MECHANICAL ADDENDUM NO. MADD-001

Project: Vaughan Willard P.S. – HVAC Upgrades

Date: December 31, 2025

1 AHU-4 (GYM) CONTROL SCHEMATIC
M-105 N.T.S.

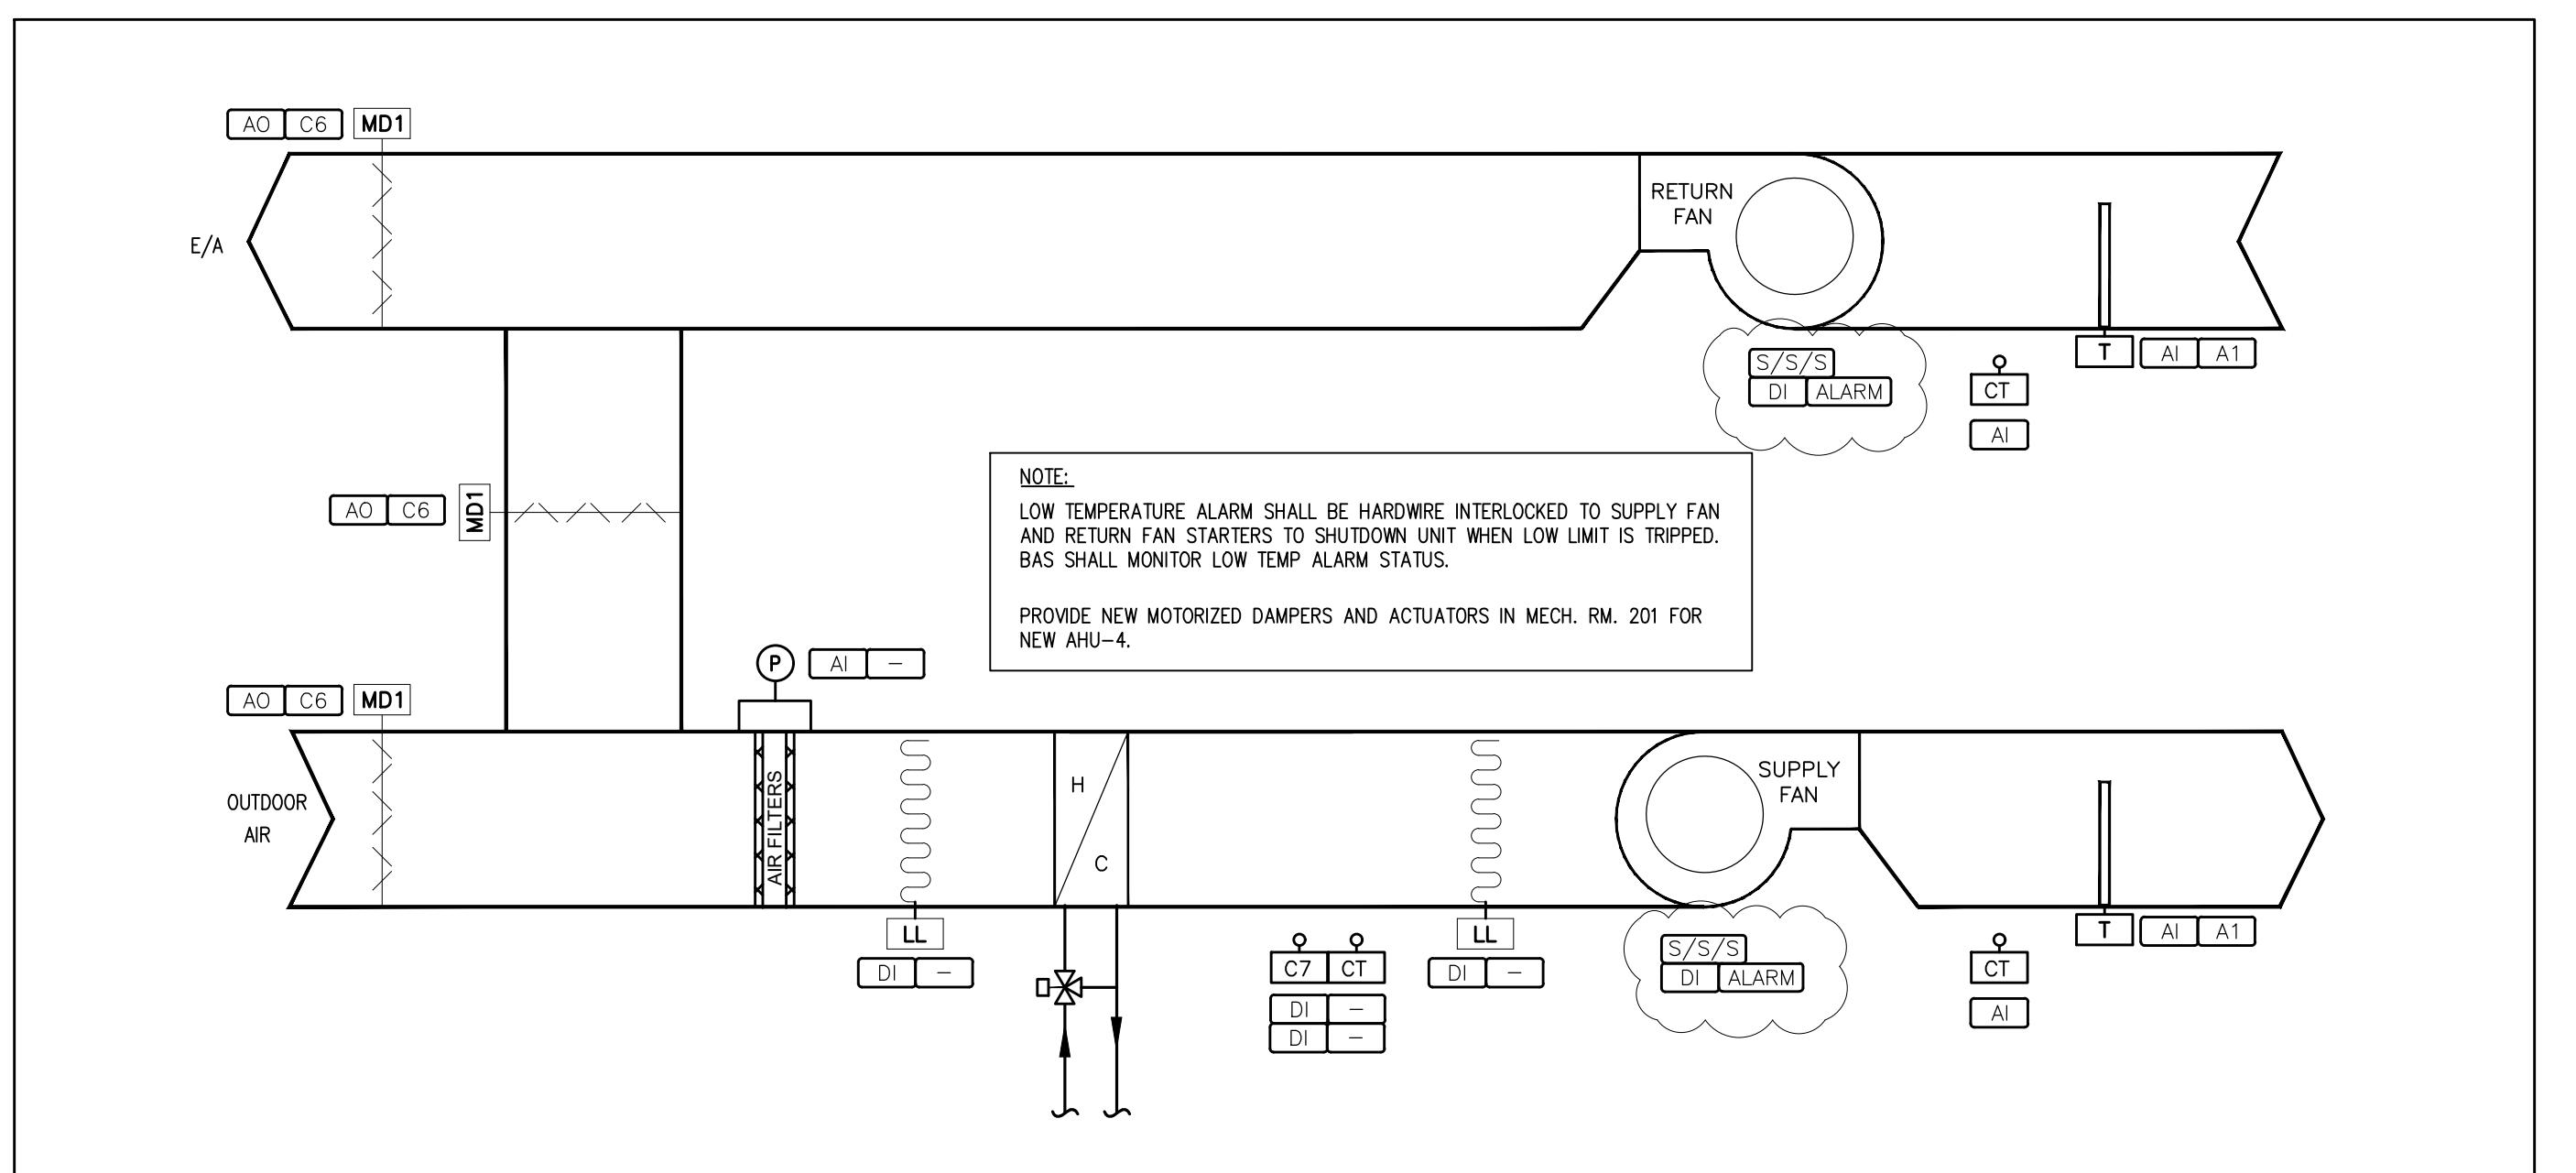
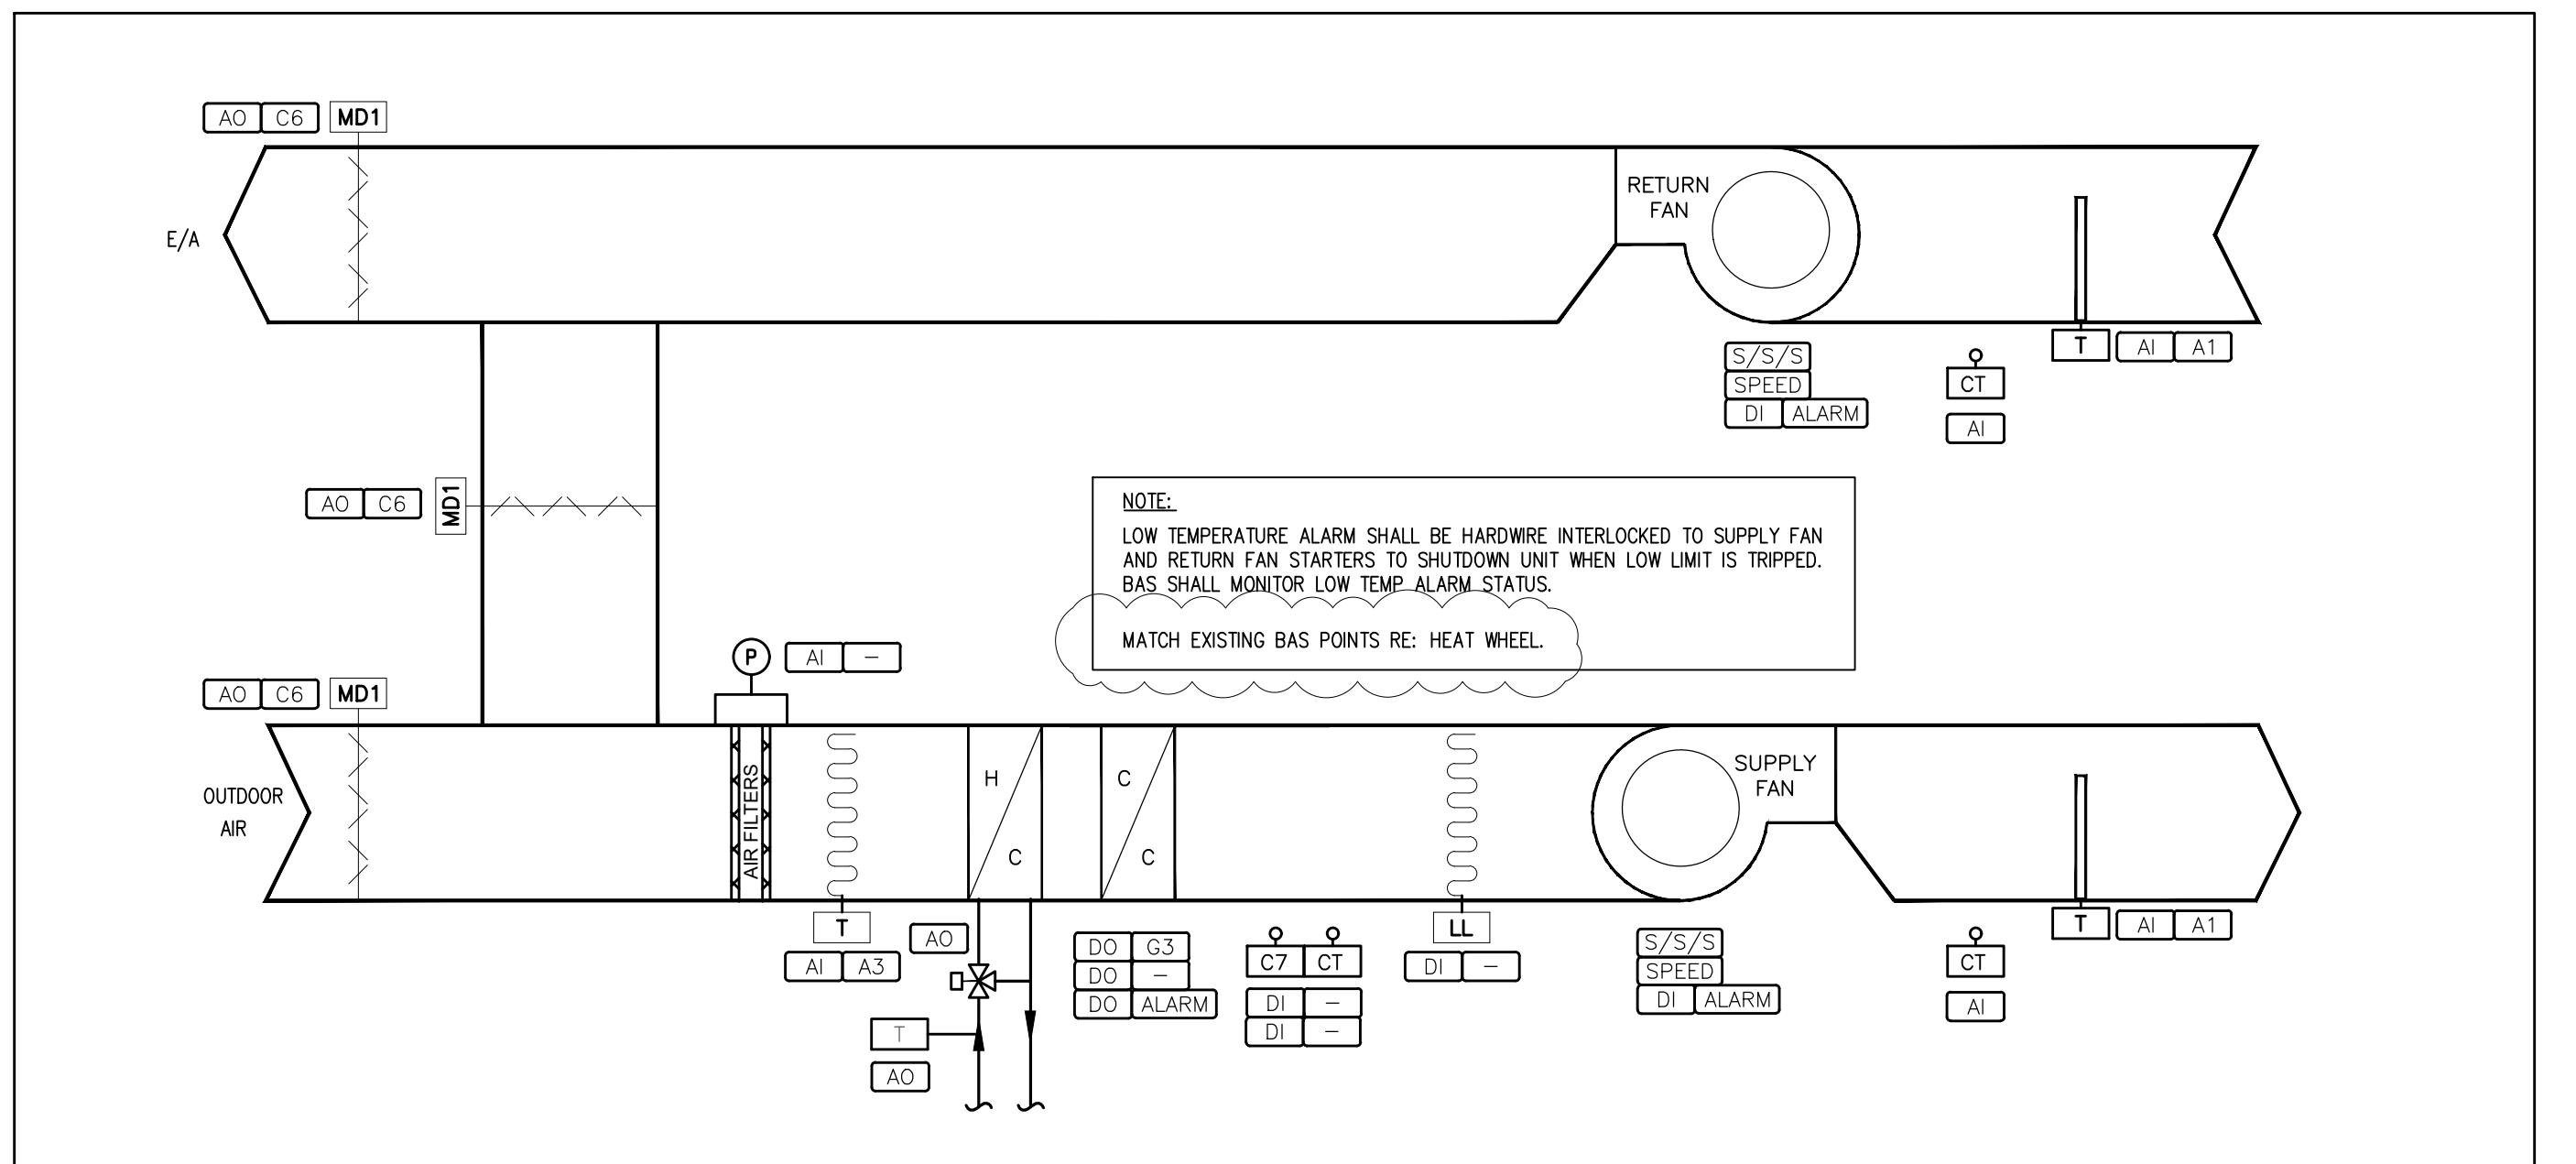
4. Refer to M-105 (Rev. 2) for highlighted changes.

- a. 1/M-105: revised supply and return fan BAS points.
- b. 2/M-105: revised notes – BAS contractor to match existing BAS points re: existing AHU-1 heat wheel.
